Three Mile Island Nuclear Station
Temporary Change Notice (TCN)

TCN NO. 2-71-030

Procedure 101-S1 Title Shift & Daily Checks

To incorporate heat balance calculation for
PCS flow determination

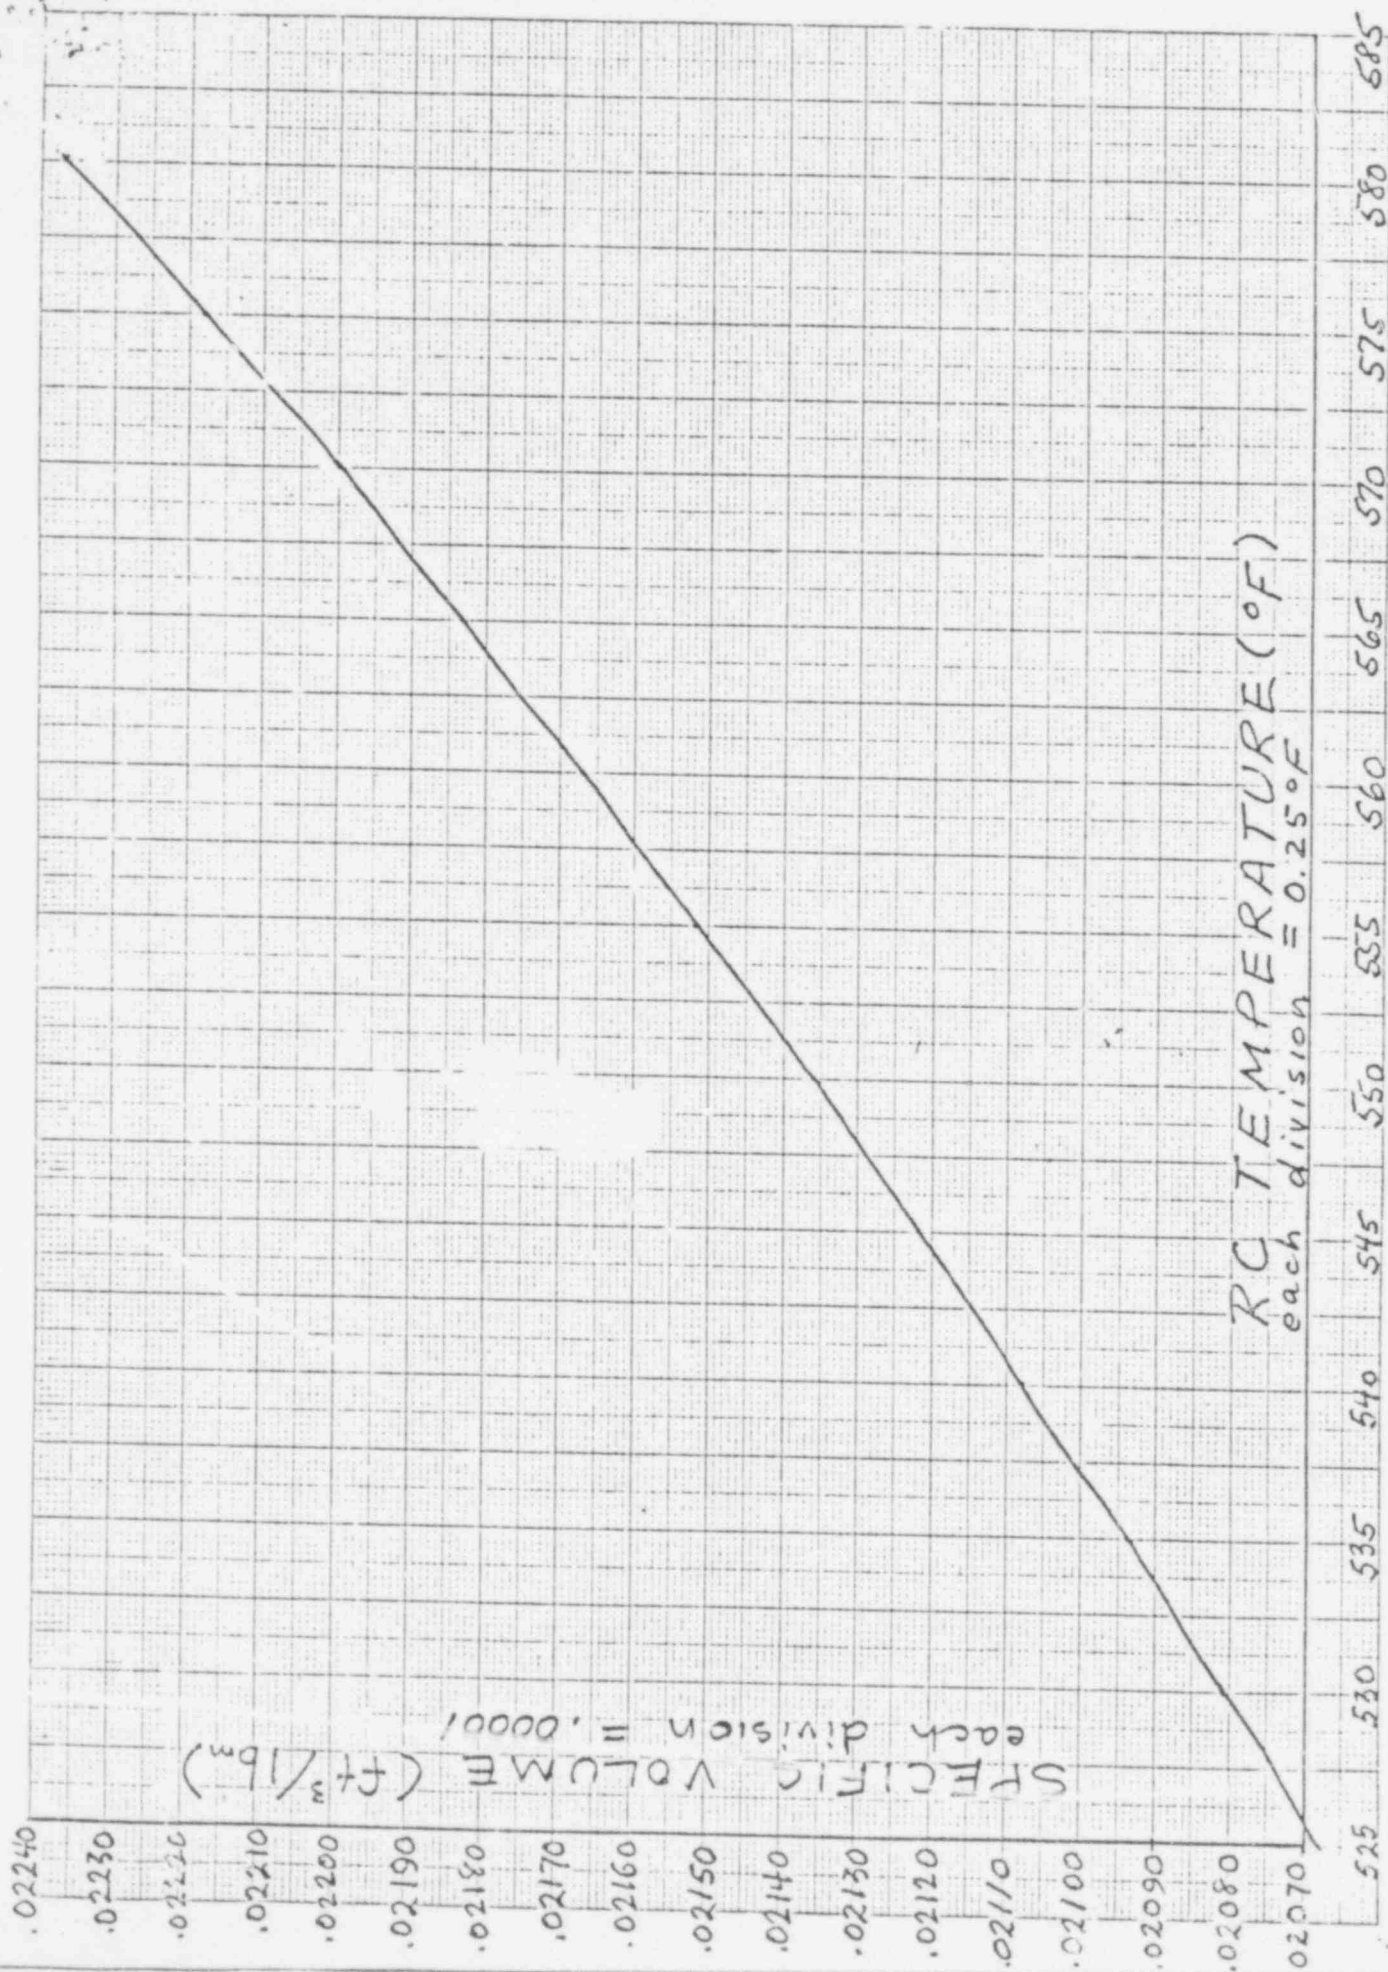
Page 10 Section 3.2.5 (total flow) from Enclosure 1
Addition of Appendix I & Figure 3 (See Attached)

C. Obtain the value for specific volume (v) for the average RC Inlet Temp. calculated in step B. See Figure 3A or 3B.
